To: Adam Grady, Hanover Design Services
From: Pat O'Mahony, Associate Planner; 910-341-0189
CC: File;
Date: 8/13/2019
Re: Masonboro Station Expansion

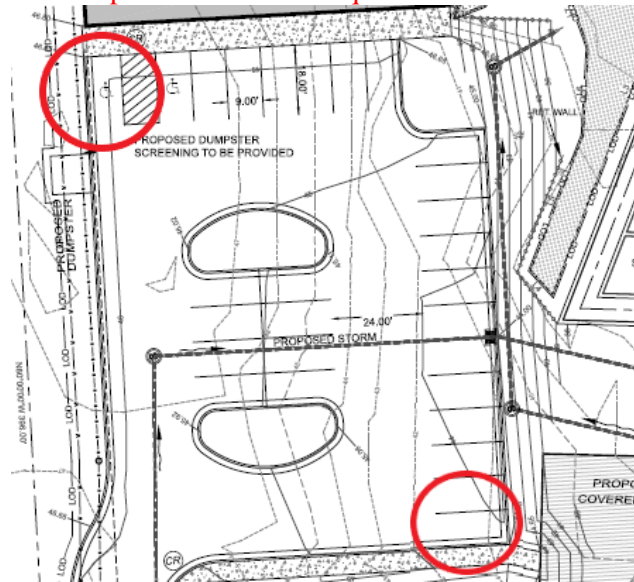
- Off street parking calculations, including required amount of parking and proposed amount of parking and the basis for determination
 - Comment: No proposed use is shown to justify the parking calculations given on the site plan. Also, 9,600 gsf requires 23 spaces, site data table shows 24 required.
 - Will there be outdoor seating on the proposed covered deck? If so, please add the restaurant deck expansion area into the parking calculation.
- Sec. 18-60 (c) (12) (13): Show names of property owners of adjacent properties, zoning, land use, owner and deed book for properties adjacent to subject property including across the street.
- Sec. 18-60 (c) (15): Show a proposed landscape plan.
 - Comment: Please provide a landscape plan showing site compliance with the Land Development Code.
 - Landscape islands will be required in the two areas shown below:
